City Planning Department

Memo

To: Cranston City Plan Commission
From: Joshua Berry, AICP - Senior Planner
Date: July 8, 2022
Re: "Trolley Barn Plaza" - Preliminary Plan - Major Land Development

Owner/App: Brewery Parkade, Inc., and Charles Montague Realty, LLC and Charlotte Montague Realty, LLC, as Tenants-in-Common, c/o First Hartford Realty, Corp.
Location: 777 Cranston Street, AP 7, Lot 1
Zone: C-5 with conditions
FLU: Highway Commercial/Services

SITE PLAN (6.23.22 version)

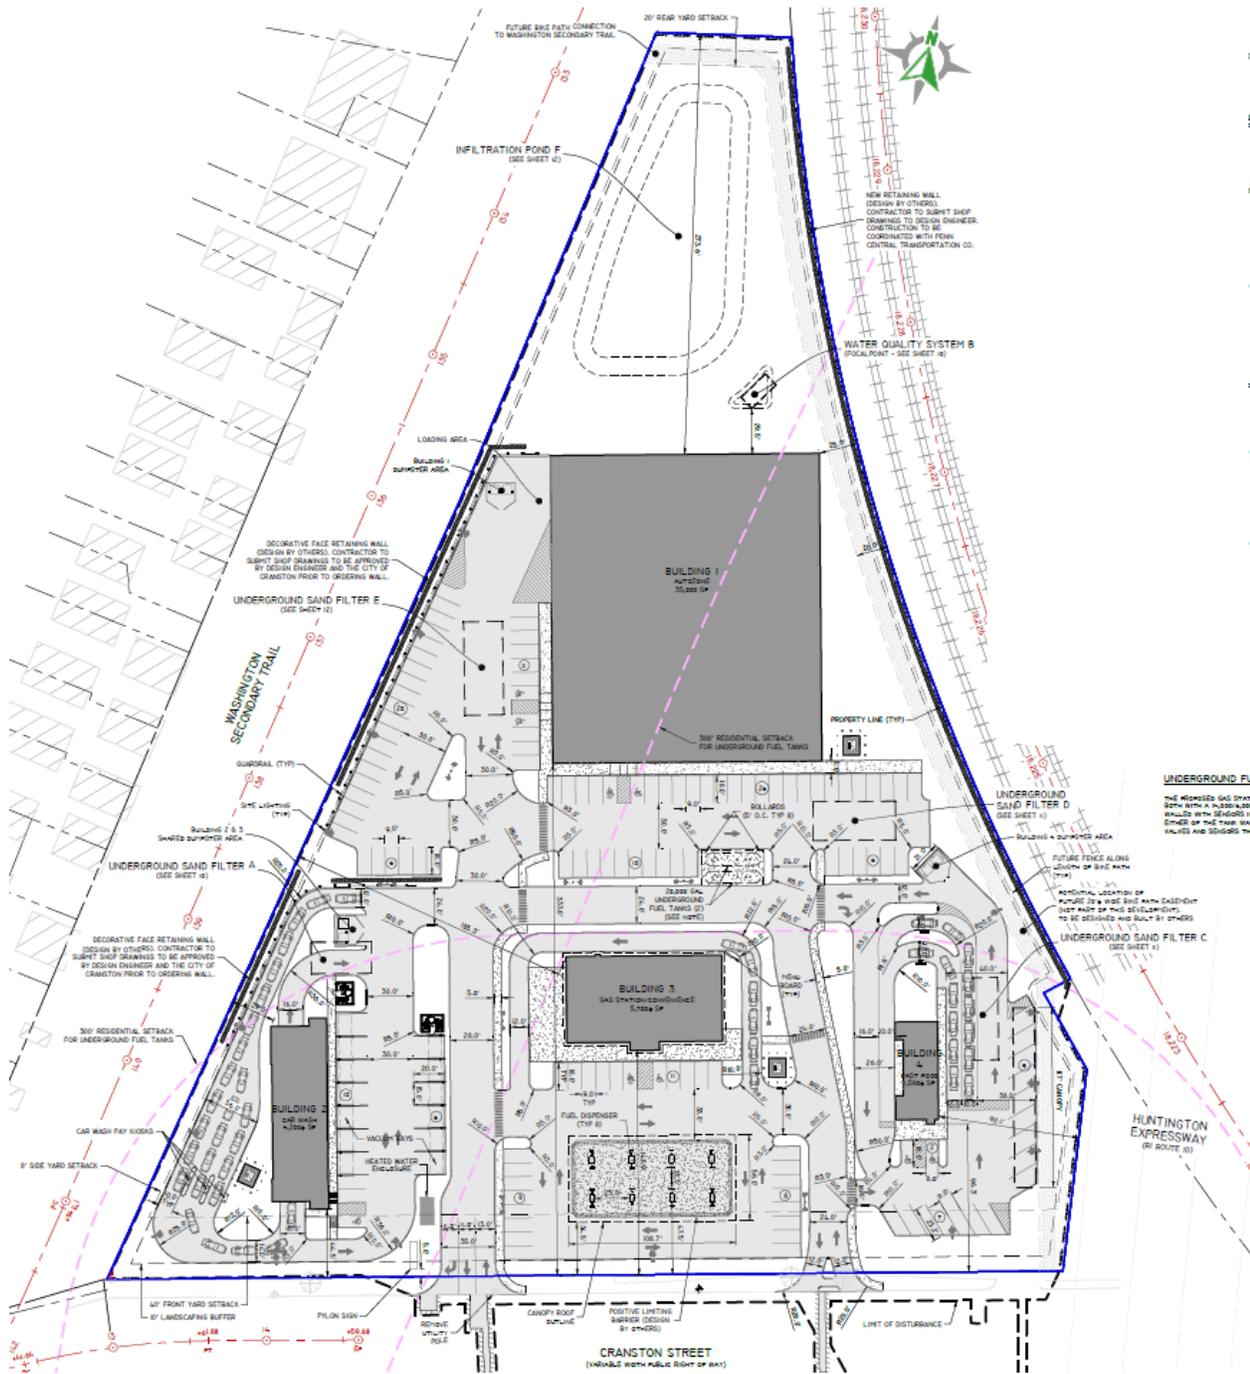
1. *It is noted that the applicant has reduced the parking from 149 to 140. We also recommend:*

a. *Adding bike racks. Applicant agrees to add to Final Plan. Bike racks can be a condition of approval.*

b. *Closing the curb cut on Cranston Street at the southeast corner of the site, replacing sidewalk and curb, and installation of an accessible ramp to facilitate future bike lane access. Applicant agrees to add to Final Plan. This can be a condition of approval.*

2. *Section 17.28.010(A)(5) and 17.84.150 (A)(2) – It is noted that the applicant has added numerous pedestrian routes to the site. We also recommend:*

a. *Connecting Building 2 sidewalk to the right-of-way, as this will likely be the access point for pedestrians entering the site that approach from the west. The applicant doesn’t believe this is necessary as Bldg. 2 is a carwash and doesn’t think it is necessary for pedestrians to walk through this portion of the site. The DPR committee was satisfied with the applicant’s response.*

b. *Connecting pedestrian route from Building 3 to Building 4 more directly with a crosswalk and sidewalk across the north side of Building 4. The applicant agreed to adding a crosswalk from the southern point of the building due west just in front of the end of the drive-through line. This can be added as a condition of approval.*

c. *Revising the light pole location to the west of the gas station canopy since it is located on the proposed sidewalk. The applicant stated that light poles are typically found in sidewalks, but that they would ensure that there is a minimum of 36” clearance. This can be added as a condition of approval.*

d. Depicting crosswalks across the two entrances on Cranston Street. **The applicant agreed. This can be added as a condition of approval.**

3. Section 17.28.010(B)(4) – *The Fast Food driveway opening (measuring curb to curb) is less than 60 feet from Cranston Street.*

4. Section 17.28.010(B)(4) and 17.48.010(D)(7) – *There is one on-site driveway opening that is located within 40 feet of another driveway opening (measuring curb to curb).*

5. Section 17.28.010(B)(5) – *There is one location where the proposed driveway width is greater than 35 feet, located on the east side of Building 4.*

6. Section 17.68.010: *As shown on Truck Movements & Dumpster Details, Sheet 13 of 15, Building #3 Fuel Truck Circulation, loading zone for fuel truck will be located in access drive behind Building 3. It is recommended that the City ask the applicant to clarify how this decision was made. This approach may be acceptable to the City since a secondary route through Building 1 is available, and based on anticipated duration/frequency/time-of-day of fueling. The applicant conveyed that the timing of the fuel truck deliveries is not during normal business hours of the proposed uses. Additionally, there are alternative routes to access all buildings if the fuel truck were to come during business hours.*

7. Section 17.84.060(D): *It is recommended that the two (2) parking spaces in the most southwestern end of the Building 4 parking lot be removed. Vehicles exiting these two parking spaces will be required to back up into the parking lot entrance and drive-thru lane exit/bypass.*

a. *F&O understands that the City will be confirming the reference point for this measurement. The city Zoning Official interprets the referenced section as to NOT apply to internal driveways, but that it only applies to driveways connecting the site to a public roadway.*

b. *If a waiver is required, F&O recommends approval of this waiver because the applicant has designated it as an entrance only, and it is 55 feet from Cranston Street. A waiver is not required.*

a. *It should be noted that the definition of “Driveway” is a private way for vehicles to move between a street and a location within a lot. Therefore, these Sections are applicable to all on-site driveway openings. The city Zoning Official interprets the referenced sections as to NOT apply to internal driveways, but that they only apply to driveways connecting the site to a public roadway.*

b. *F&O recommends approval of this waiver because the proposed driveway openings are 30 feet apart, and one driveway opening is a one-way (i.e. Building 4 entrance). A waiver is not required.*

a. *F&O recommends approval of this waiver since the driveway width is 40 feet, and 20 feet of that width will be utilized for two drive-thru queuing lanes. The city Zoning Official interprets the referenced sections as to NOT apply to internal driveways, but that they only apply to driveways connecting the site to a public roadway. The applicant made efforts to reduce the internal driveway widths within reason.*

The applicant did not feel that this was a safety issue, but is a situation normally found in urban development. The DPRC was satisfied with this rationale.

3. Bike racks shall be incorporated in safe and appropriate locations to be reviewed by the Cranston Planning Department as part of the Final Plan application.

4. The curb cut on Cranston Street at the southeast corner of the site shall be replaced by sidewalk and curb matching the adjoining sidewalk and curb and shall installation an accessible ramp to facilitate future bike lane access. This shall be shown on the Final Plan application.

7. A pedestrian crosswalk from the southern point of the building due west just in front of the end of the drive-through line shall be added and made part of the Final Plan application.
8. All light poles will be located so that a minimum of 36" of clearance is maintained on all external and internal sidewalks.

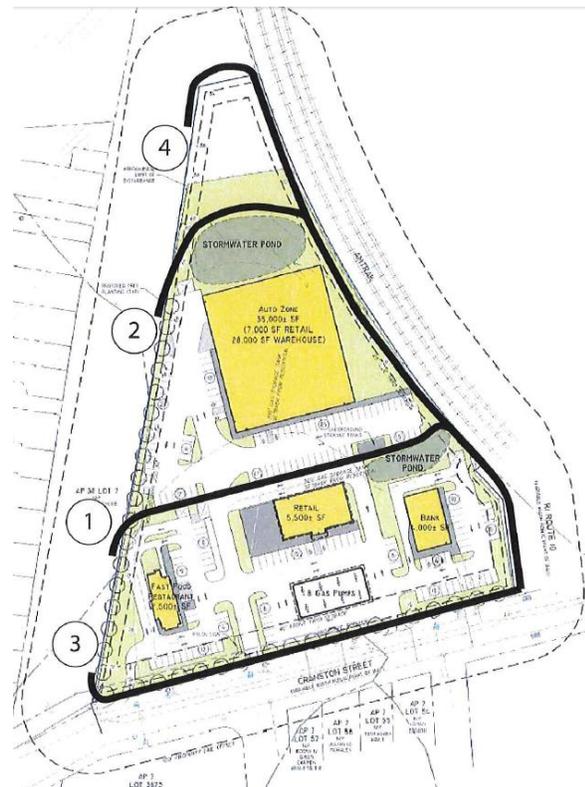
1. Master Plan condition of approval #6 mandated that the applicant coordinate the bath path connection with Cranston and Providence planning departments. It stipulated that this “may include the applicant granting an easement (roughly 15’ wide) in a location similar to Route/Option #2 as identified in the letter addressed to Jason Pezzullo from Bonnie Nickerson of the Providence Department of Planning and Development, dated 10/19/21.” This is the referenced exhibit:

2. The applicant has complied with this master plan condition. This benefit should not be understated, as the state has struggled to find a solution for the bike path connection for years. The applicant has designated a **20'-wide** strip along the eastern and northern property line to accommodate the future bike path. The site plan has been clearly marked and the agreement with the applicant is to condition the bike path easement to be granted by the owner at the time when the necessary information is available to execute the easement.

3. The bike path future easement location is more aligned with option #4 in the exhibit above than option #2. The reason for this is that the grading around the infiltration pond eliminated option #2 from being feasible. This was found acceptable by Cranston and Providence planning departments.

2. Bike path easement of 20’ shall be granted to a party to be confirmed by the City of Cranston Planning Department once the necessary information is available.
